ADDENDUM NO. 1

PALESTINE-HOLLANSBURG JOINT SEWER DISTRICT Centralized Wastewater System Contract 'B' - Wastewater Treatment Facility

Re: Palestine-Hollansburg Joint Sewer District Centralized Wastewater System – Contract 'B' - Wastewater Treatment Facility

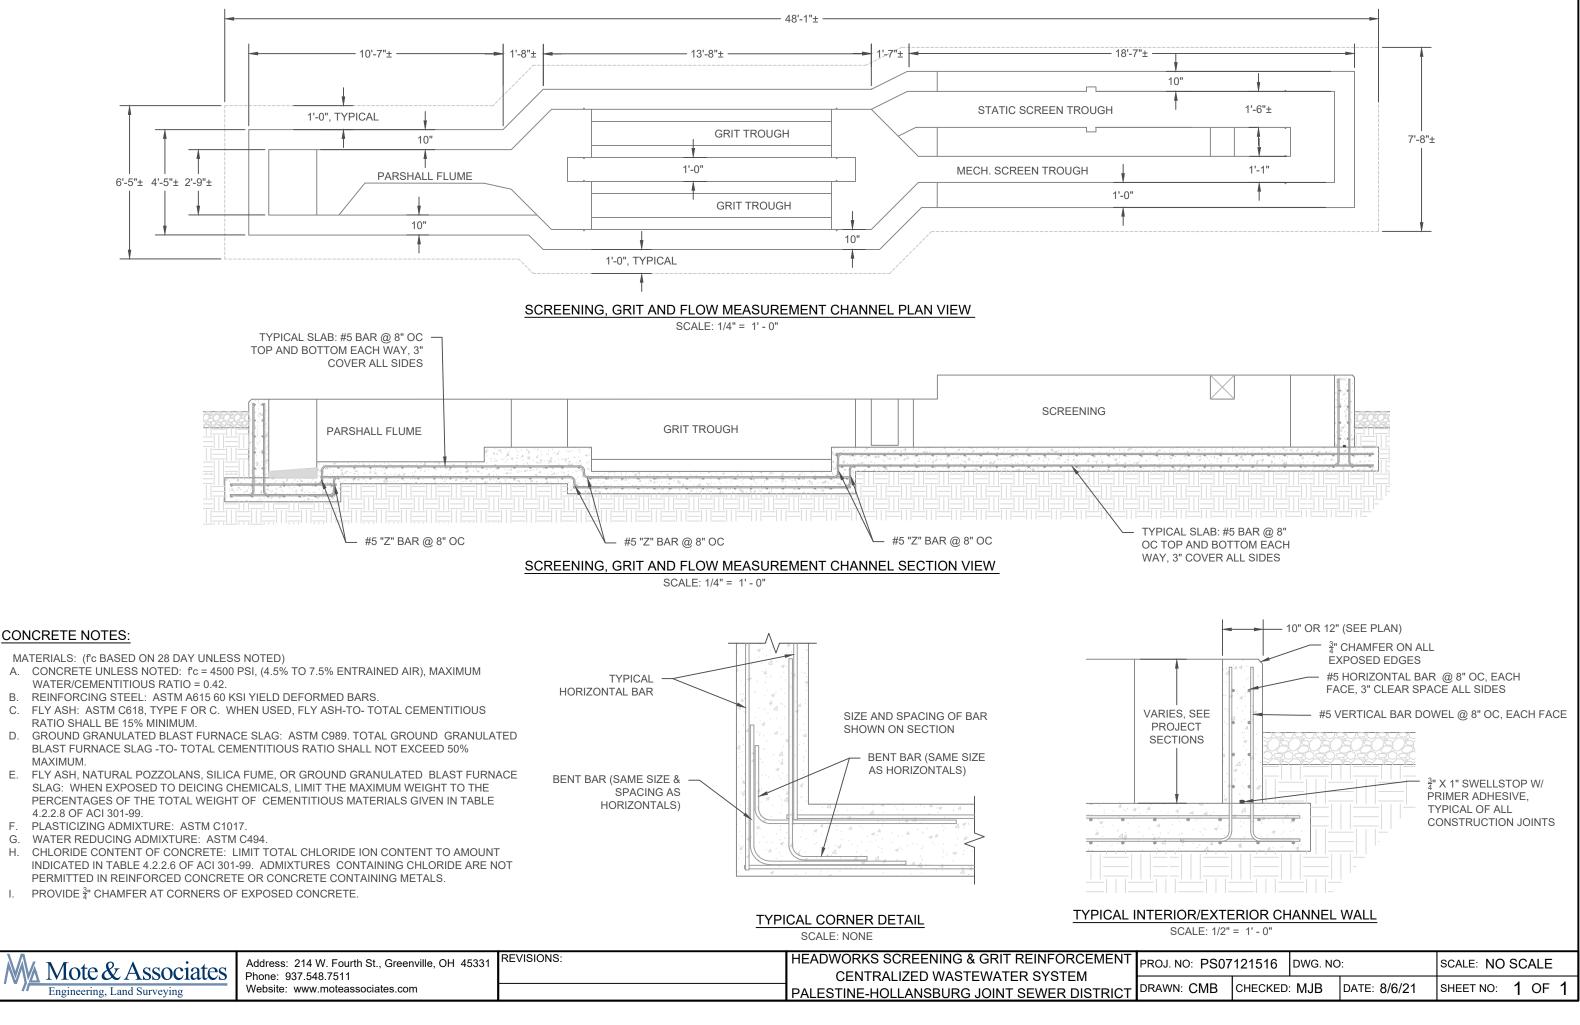
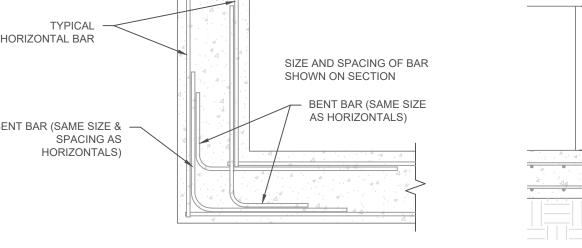
2. <u>Sheet #8 of 17, HEADWORKS SCREENING & GRIT–WASTEWATER TREATMENT FACILITY</u>

A Screening & Grit Structure Reinforcement Detail is attached to this Addendum to provide additional information to the work contained on this Sheet #8.
